Location:	530 – 32nd Street (see map on reverse)
Assessors Parcel Numbers:	009-0716-009-00
Proposal:	Appeal of Zoning Manager's approval of application for Regular Design Review to construct a new 5-unit townhouse residential development on a vacant lot.
Appellant:	Tanya Boyce on behalf of Clarence McElhaney, Jr. (510) 932-5416
Contact Person/Phone Number:	Robert Brecht (510) 928-1611
Owner:	530 – 32 nd Street LLC
Planning Permits Required:	Regular Design Review for a new 5-unit residential development.
General Plan:	Urban Residential
Zoning:	RU-1 Urban Residential Zone 1
Environmental Determination:	Exempt, Section 15332 of the State CEQA Guidelines; infill development; Section 15183(a), projects consistent with a community plan, general plan or zoning
Historic Status:	Not a Potential Historic Property (PDHP); Survey rating: N/A
Service Delivery District:	2
City Council District:	3
Status:	Application approved on 4/2/14; Appealed on 4/14/14.

Action to be Taken:	Public Hearing
Staff Recommendation:	Deny the Appeal thereby upholding the Zoning Manager's approval
Finality of Decision:	Final Decision
For further information:	Contact case planner Maurice Brenyah-Addow at 510-238-6342

1 ARCHITECTURAL SITE

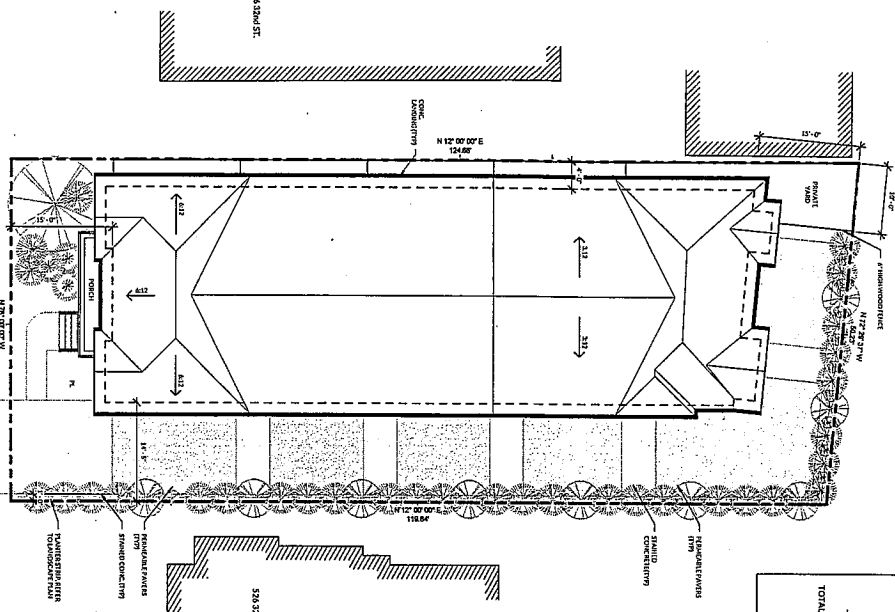
B) *The open space calculations on the submitted plans are incorrect.*

- A) *On the site plan the driveway width is labeled as 14'-5", page A2 shows the actual width as being 13'-5", however a survey conducted by the adjacent property owners indicates that the fence is off the property line by almost 2'-00" thereby further reducing the actual driveway width.*

- B) *As illustrated, the vehicular turn overlay does not work. As shown, the cars must drive through the planting strip to make the turn. Furthermore, the driveway appears to get more narrow as it gets further away from the street, however the vehicular overlay only covers the first garage, leaving it questionable as to whether that turn can work for any of the other garages.*

Staff's response: Depending on how one calculates the open space, one can arrive at different conclusions. Staff conducted a conservative calculation that disregards spaces that, although functionally work as open space, fall short of the technical dimensions of official open space dimensions. Staff concluded that the project provides a minimum of 1,050 square feet of total open space (600 public, 450 weighted private) where 875 square feet is required for the entire project.

Staff's response: The plans show a minimum driveway width of 18 feet (where 9 feet minimum is required) and a maneuvering aisle of 21 feet (minimum width required) in front of every garage. The dimensions quoted by the appellant are actually the setbacks for portions of the upper floor cantilevered over the driveway.

Staff's response: Staff does not see any evidence of cars needing to maneuver through planting strips. The 21-foot code-required maneuvering aisle stops short of the edge of the planting strip. Tree canopies that may appear to overhang the driveway and fence should not be misinterpreted as obstructions. The driveway and maneuvering aisle widths are consistent throughout the site plan.

1 SOUTH ELEVATION (FRONT)
SCALE: 1/4" = 1'-0"

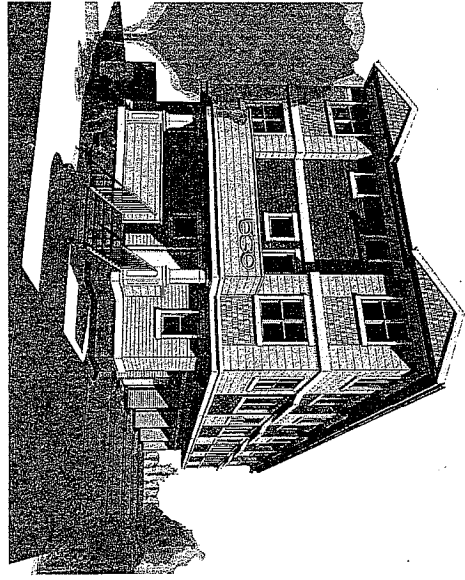
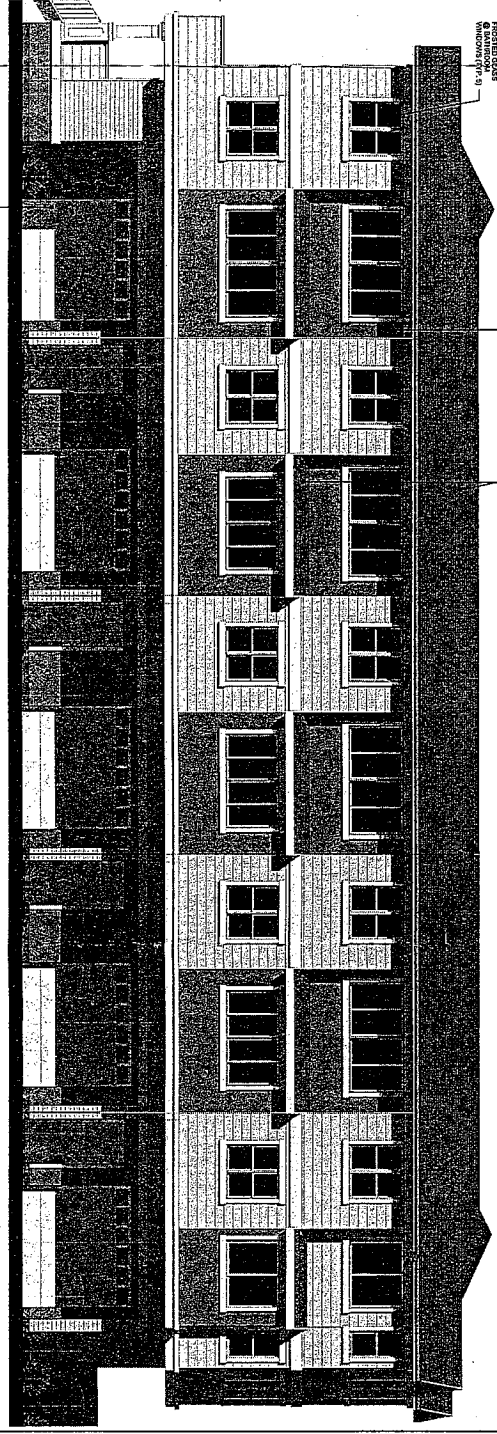
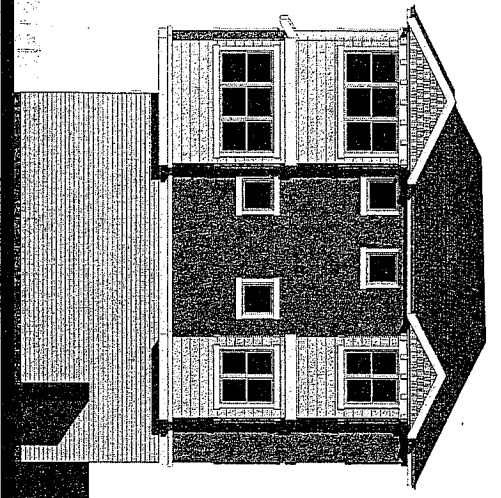
- D) *The presented plans do not address fencing; however without a fence the false porch provides a perfect opportunity for homeless encampment and other illicit activity in the covered and used entryway.*

Staff's response: The street-facing elevations show sufficient real windows (not false) typical of other buildings in the neighborhood. The living room window of the front facing unit faces the street. Since residents are likely to spend more time in the living room or on the street-facing porches on the ground or upper floors, the eyes-on-the-street argument lacks basis.

Staff's response: Most neighboring buildings with porches, including the appellant's home next door with a similar street-facing porch, do not have fencing. It is not clear why the proposed porch, which was actually modeled after the context in the neighborhood, should be fenced. The driveway entrance can be gated to further secure the site but it should be the prerogative of the property owner(s) to choose to have a fence if they so wish.

A5

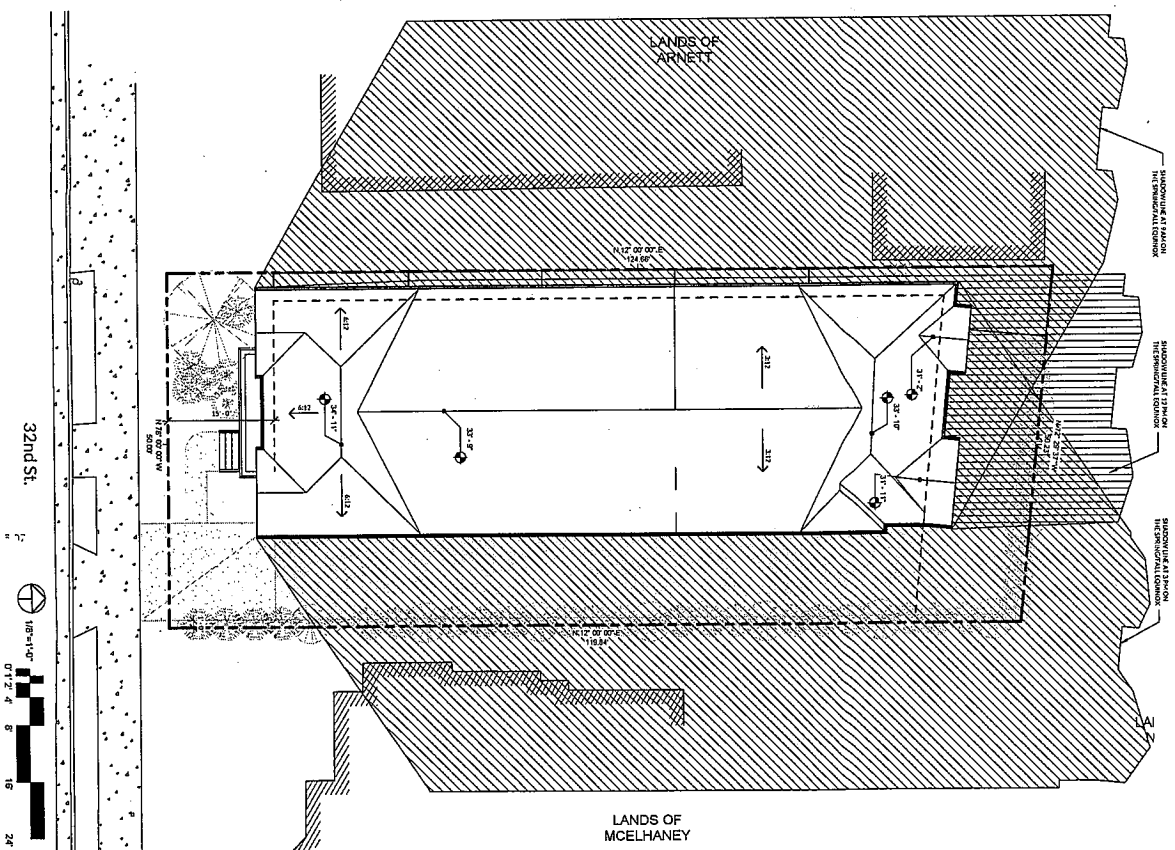
- B) *The shadow appears to be quite significant over the eastern bedroom windows and over the planting areas of the yard. We would like to request an animated study so we can assess how the shadow moved over our property over time.*

- A) The submitted shadow study is incorrectly labeled as every shadow line is labeled as 9am on the spring fall equinox . Without a properly preparing study, it is not possible to accurately assess the impact of the shadow on our home.
- B) The shadow appears to be quite significant over the eastern bedroom windows and over the planting areas of the yard. We would like to request an animated study so we can assess how the shadow moves over our property over time.
- C) With all units facing east, the adjacent parcel will have a bank of bedroom windows aligned with our existing bedroom windows and directly overlooking our rear yard impact
- D) Since the front doors are facing the side property line, porch lights will also be facing the side property line, resulting is motion lights shining into the bedrooms of our home at night.

Staff's response: Staff's review of the shadow study prepared by the applicant shows that although there is a mislabeling of the three critical times, the actual shadow analyses were properly done per applicable standards and reveals there are no significant adverse solar impacts on the adjacent property located to the east at 526 32nd Street. The appellant has not submitted any alternative study proving otherwise to support this claim.

- C) **Staff's response:** Per standard shadow impact criteria, shadow impacts exist when shadow is cast over 50% of an actively used space during at least two of the three critical times (9am, 12 noon, and 3pm) during the Spring and Fall Equinox. In this particular case, shadow is only cast during the 3pm period and there are no shadows whatsoever at 9am or 12 noon. Hence there is no significant shadow impact based on the applicable criteria. *With all units facing east, the adjacent parcel will have a bank of*
